CITY OF ALBUQUERQUE

PLANNING DEPARTMENT – Development Review Services

Re: Vista Vieja Unit 3
Certification for Financial Guarantee Release
Cert Date 5-3-2011 – D09D003

Exhibit A – Carrillo Memo
RE: Vista Vieja Building Permits 1/18/2016

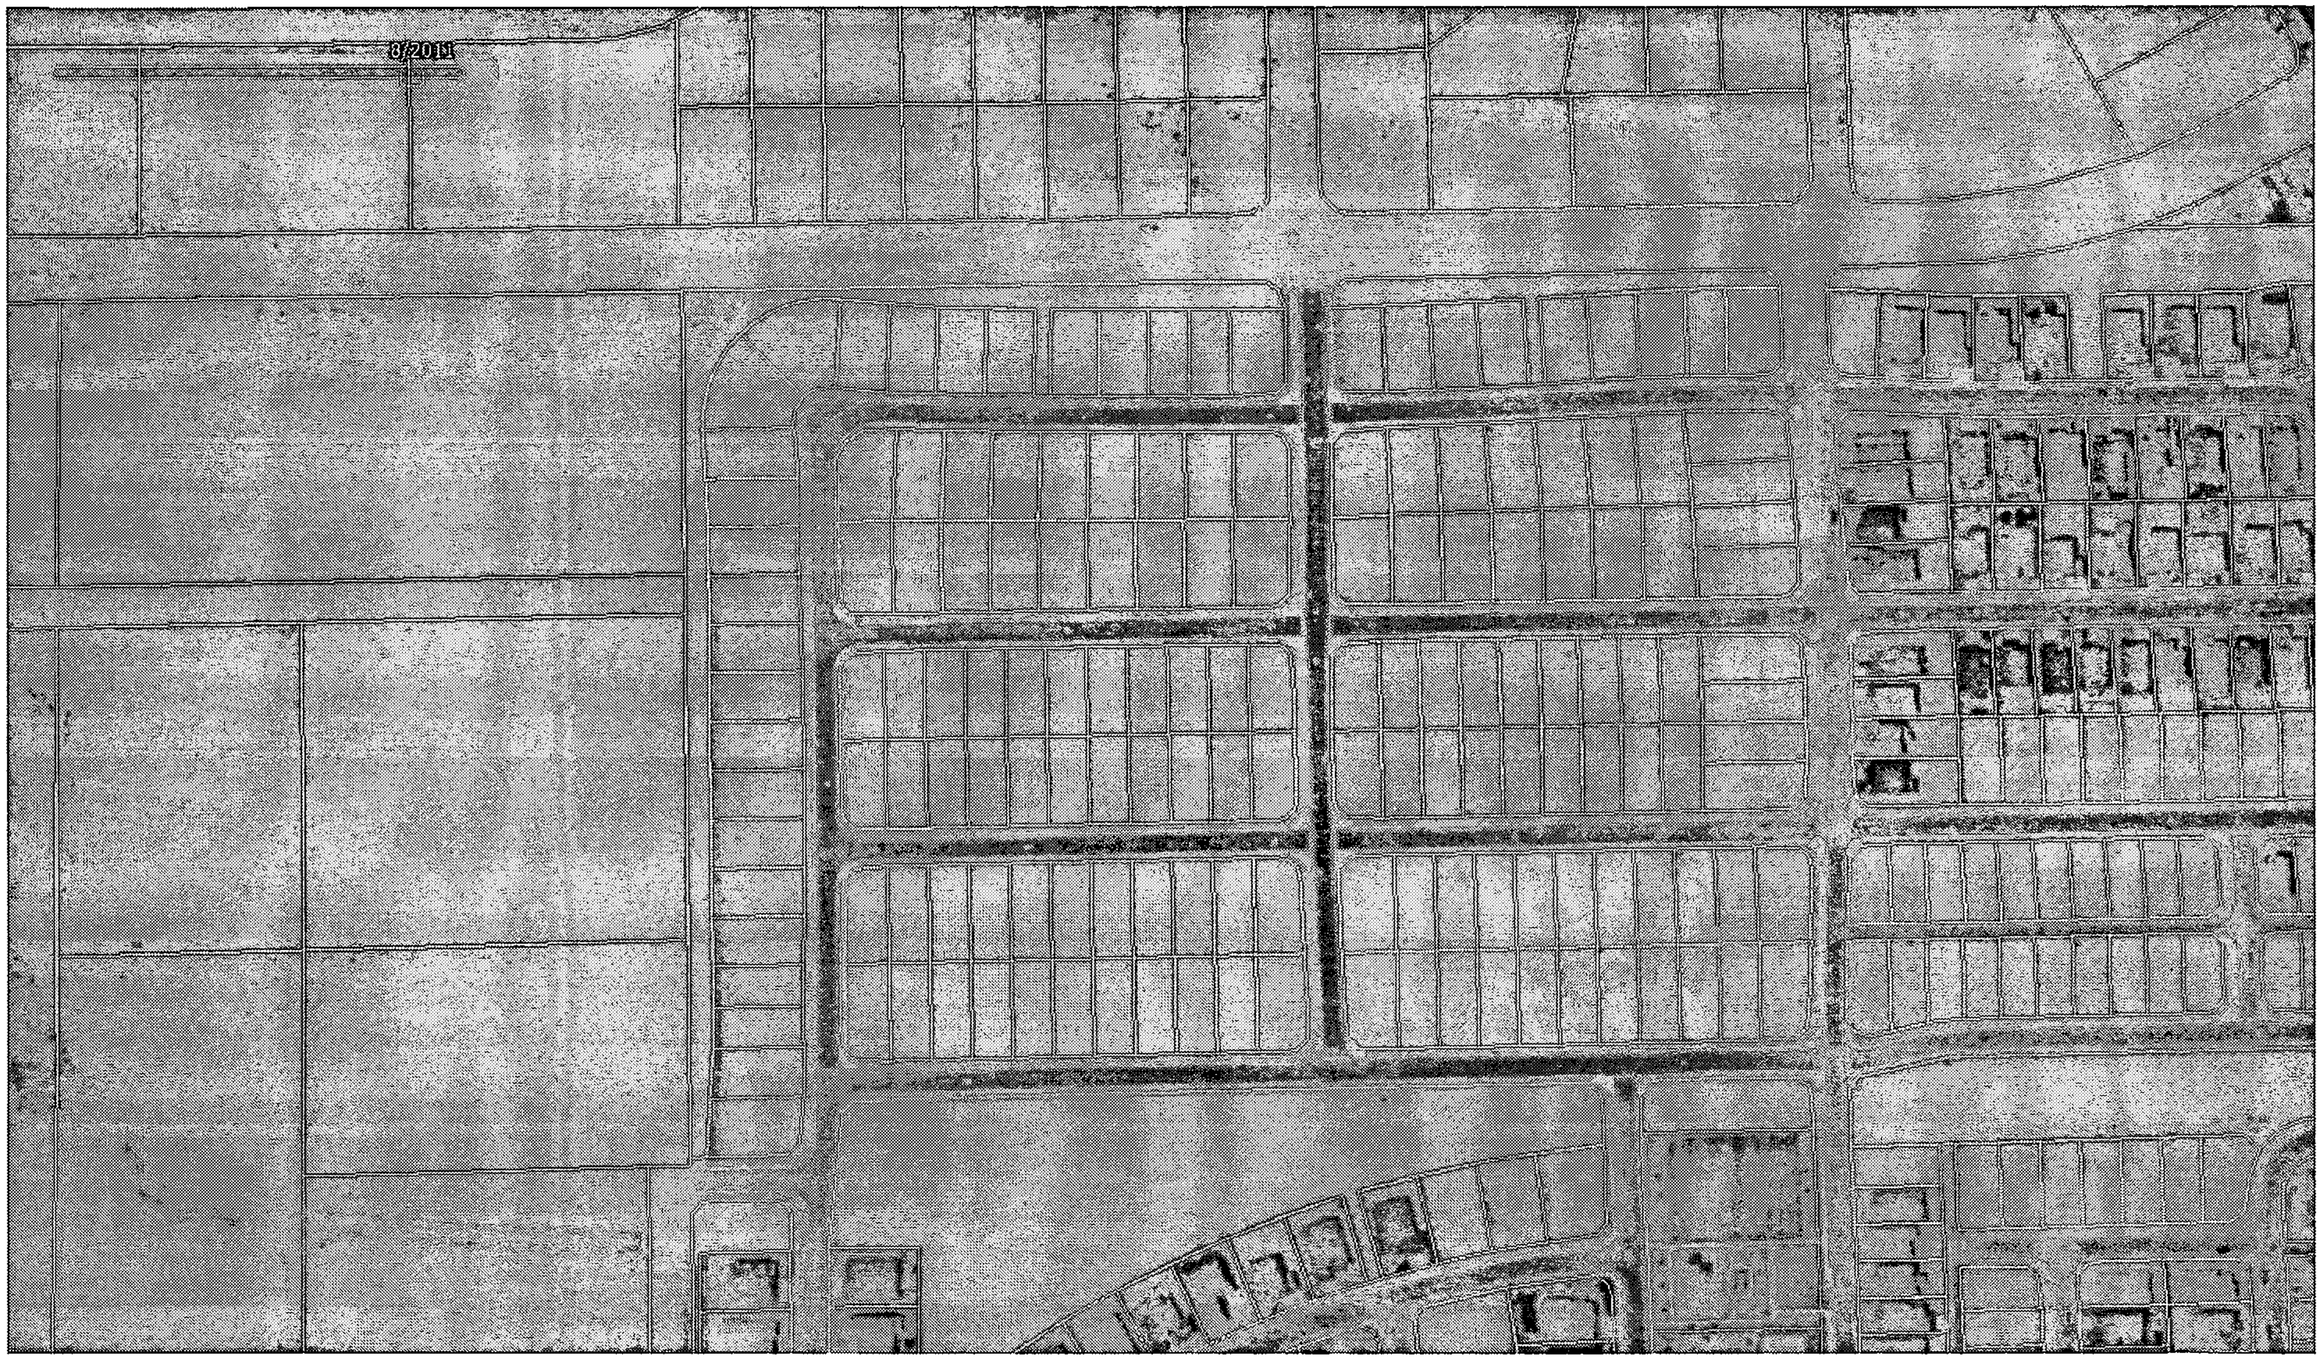
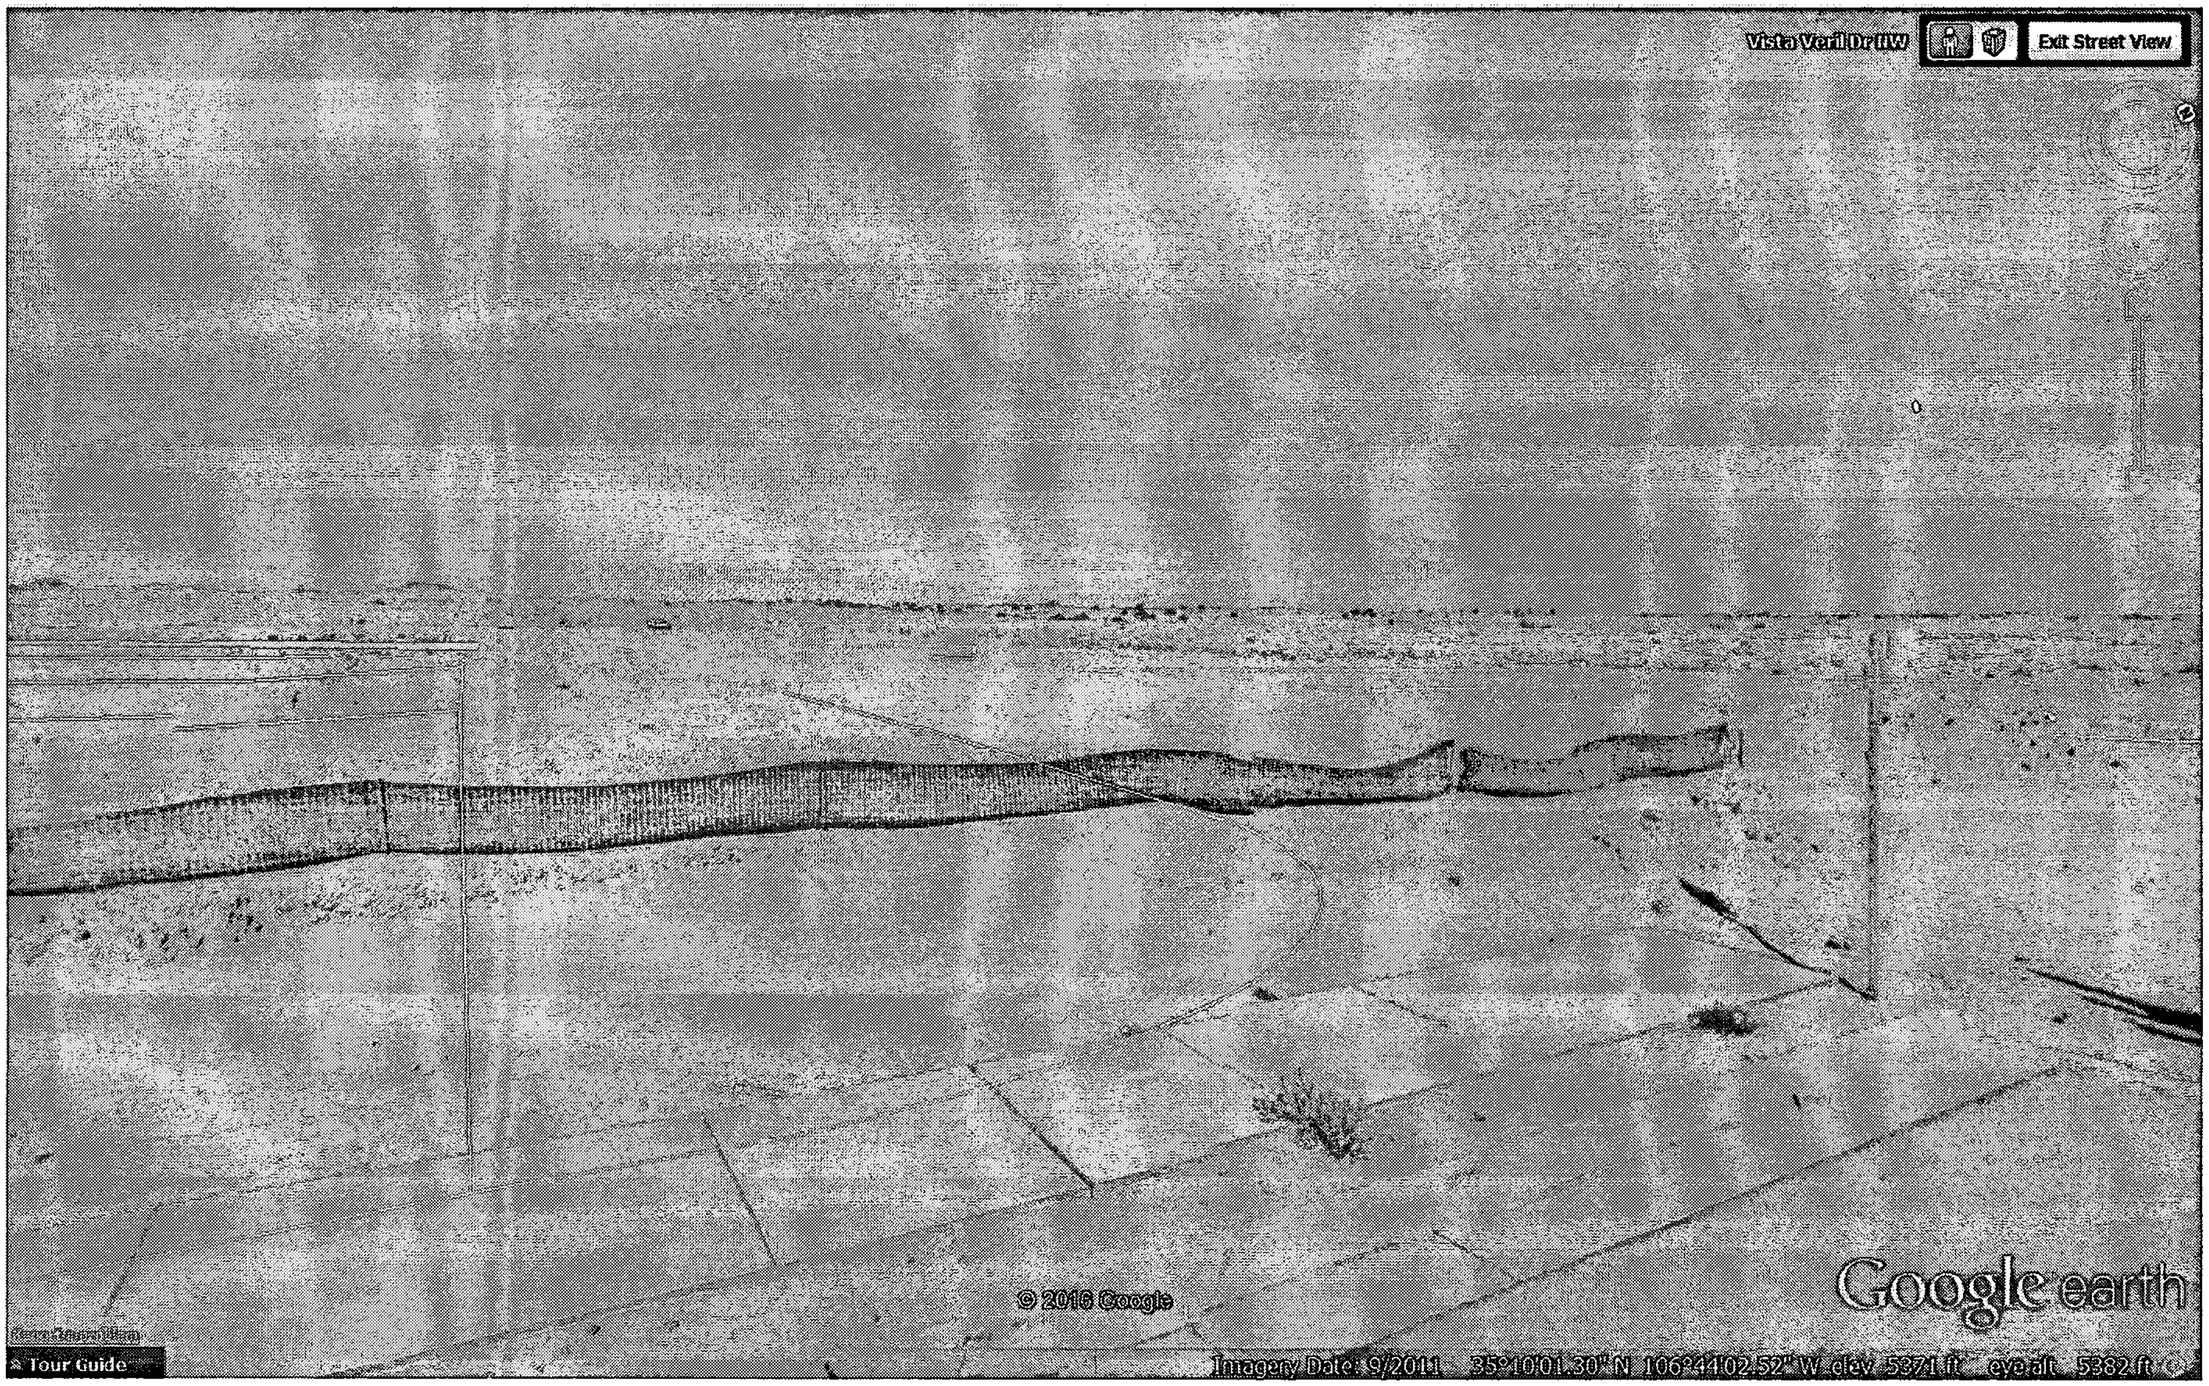
As of the date of this memo, a dirt pile and rubble exists within Scenic Drive right of way. However, after reviewing aerial photography between 2011 and 2014, there is enough evidence to show that the dirt pile was removed by the Vista Vieja development on or before August, 2011. A new dirt pile and stockpiling activity is visible in March 2014. Some activity adjacent to the right of way can be seen in January 2013 aerials. (Source: Google Earth Pro)
